SUBJECT: UMTRA Project - Grand Junction
Dredge and Fill Permit Application

SUBJECT: UMTRA Project - Grand Junction
Floodplain Permit

REVIEW SHEET SUMMARY

FILE NO. 30-88 TITLE/HEADING Floodplain Permit DUE DATE 8/30/88

EXISTING CONDITIONS PLAN

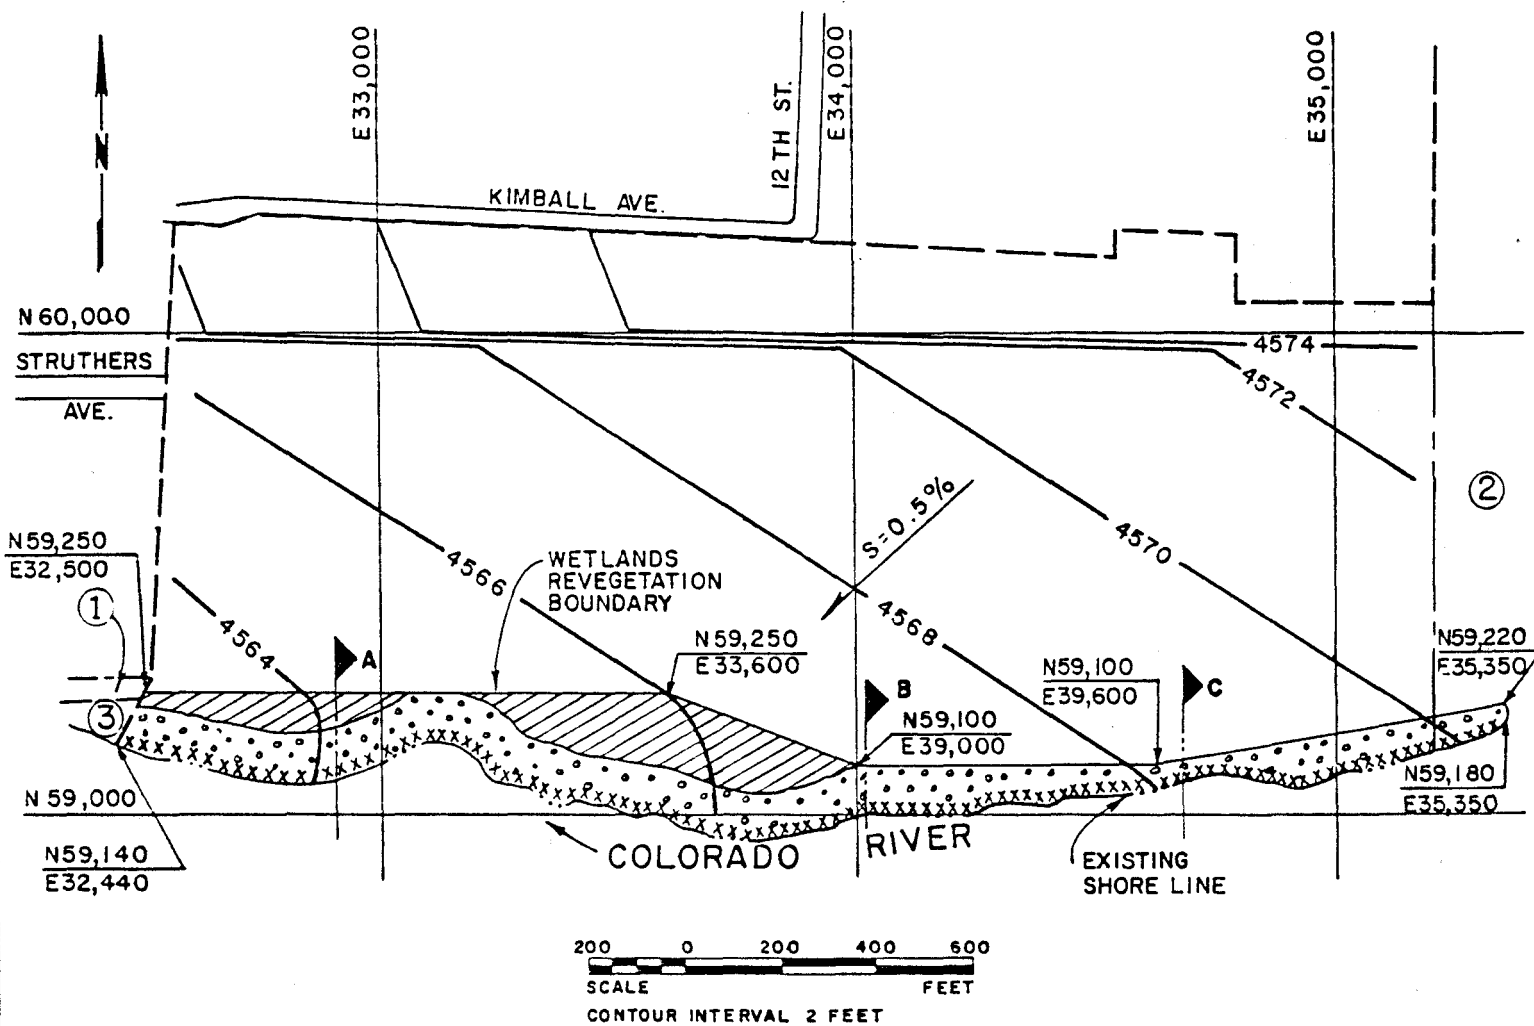
8/30/88 Planning Sheet one of four shows the State-owned temporary repository site included as part of the project. However, sheets two through four, and the cover letter to Grady McNure, do not show or mention the State repository. The floodplain permit should include the repository and a final site plan and cross-sections should be provided for this area.

- o State Repository: Exhibit A shows the final grading plan of the project area including the State Repository. Exhibit B shows a cross-section of the State Repository.

FINAL SITE PLAN

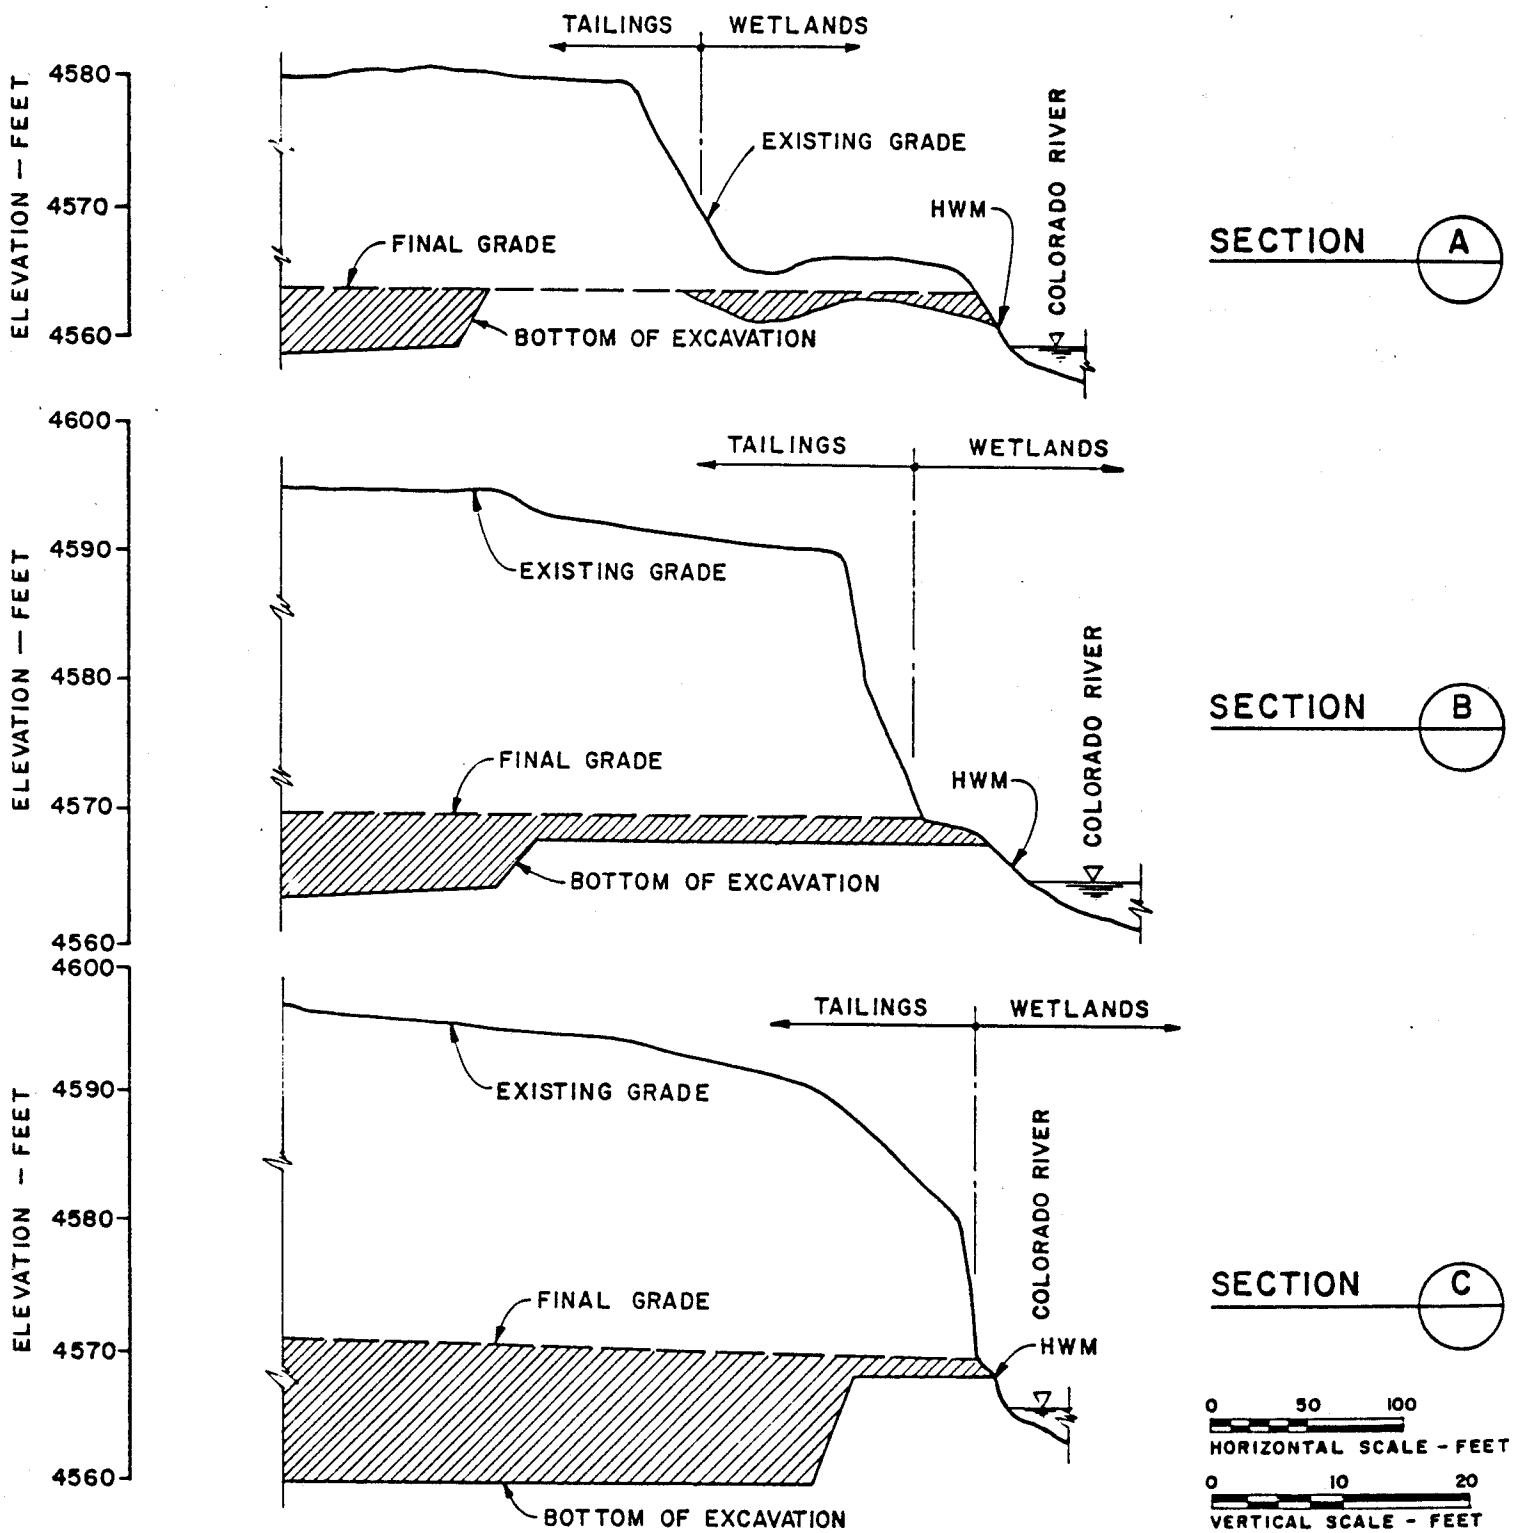
The new 100-year floodplain boundary needs to be shown on the final site plan.

The revegetation plan is acceptable if it includes the State repository site. Sheet three of four should be expanded to include that site.

- o Revegetation Plan: The State Repository will be reseeded as specified in the 404 application filed with the Corps. It should be noted that only a small portion of the State Repository contains Corps-defined wetlands.

FEMA
100-YR. FLOOD BOUNDARIES
AT END OF PHASE I-A

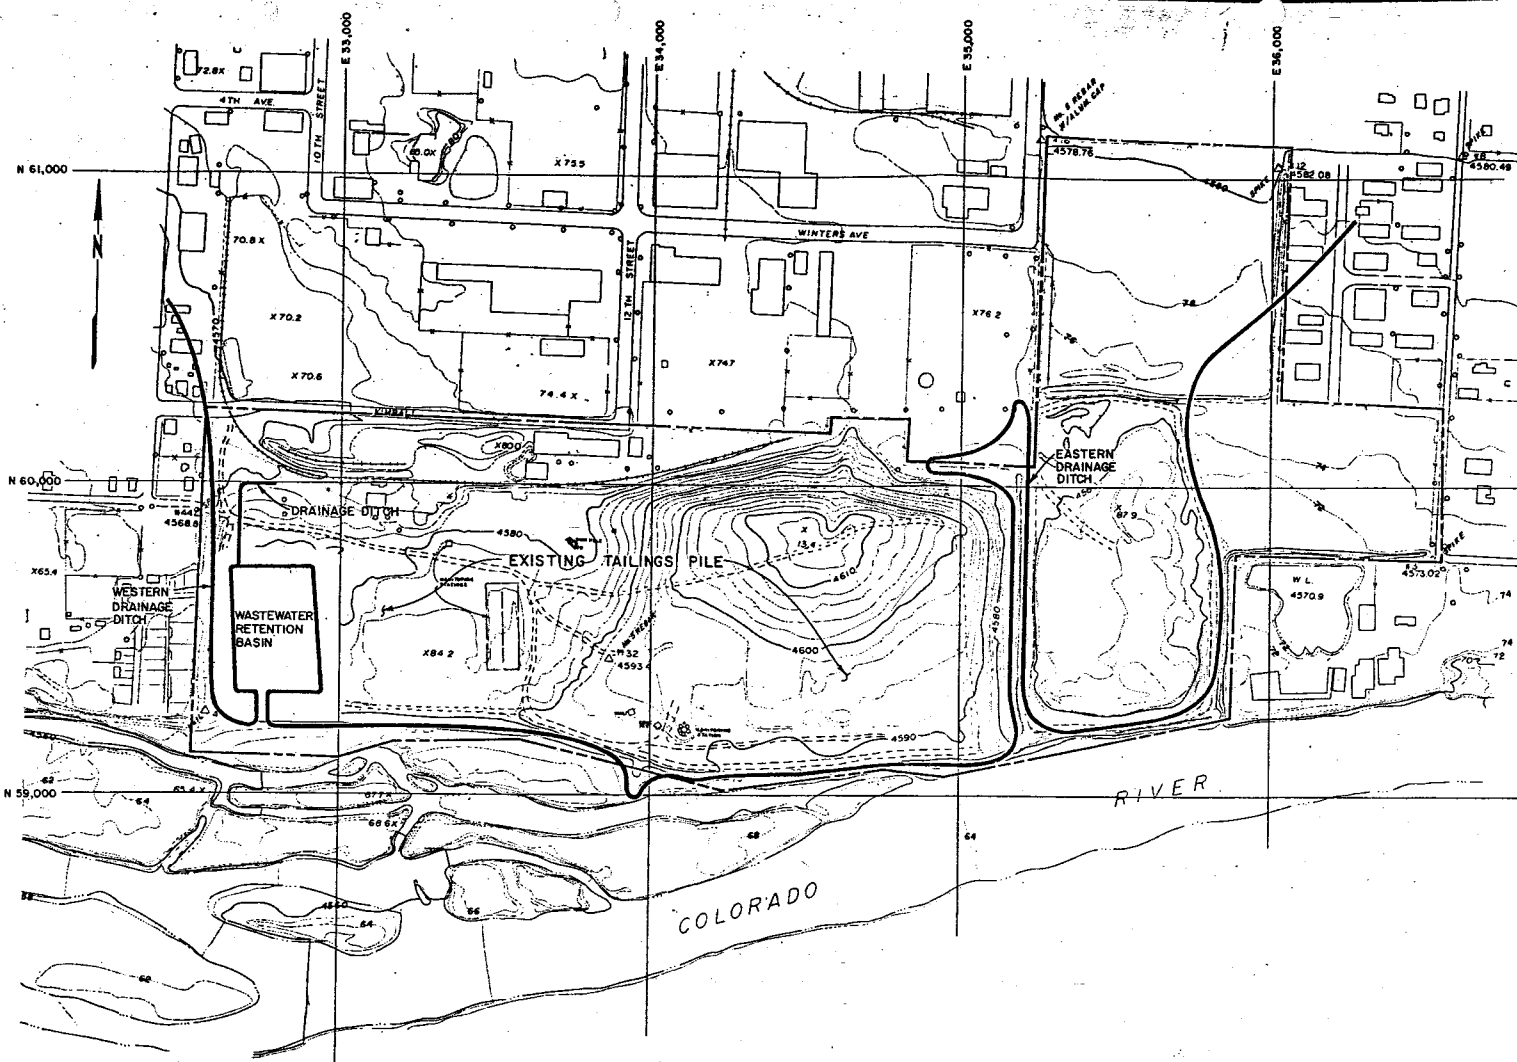
The current uranium mill tailings pile acts as a constriction to 100-year flows. Removal of this constriction has the potential of increasing flood impacts on upstream or downstream users. Prior to issuing a permit we will require a hydrological study that certifies that there will be no adverse impacts on other properties. If adverse impacts are identified, a mitigation plan will be required. The study must be conducted and signed by a qualified hydrologist or hydrological engineer.

- o Hydrological Study/Floodplain Boundary: Exhibit C discusses the predicted changes in the 100-year flood levels in the vicinity of the project site at the end of Phase IA and at the conclusion of the remedial action (Phase II). Exhibit C was developed by Morrison-Knudsen Engineers, Inc. to satisfy the requirements of Item Z - Flood Hazard Report - of the Mesa County Conditional Use Permit application. The 100-year flood levels are based on the January 6, 1983, Federal Emergency Management Agency (FEMA) flood insurance rate map of Grand Junction. Although not depicted on Figure Z-1 to Exhibit C, the existing 100-year flood boundary is nearly identical to the flood boundary depicted at the end of Phase IA. The only difference is the extension of floodwaters into the proposed retention basin and along the project drainage ditch leading into the retention basin.

As shown in Figure Z-2 to Exhibit C, the removal of tailings and the regrading of the project site will have the effect of moving the 100-year flood boundary inland but still within the boundaries of the project site. The 100-year flood boundary beyond the project site, either upstream or downstream, will not be affected by the UMTRA Project.
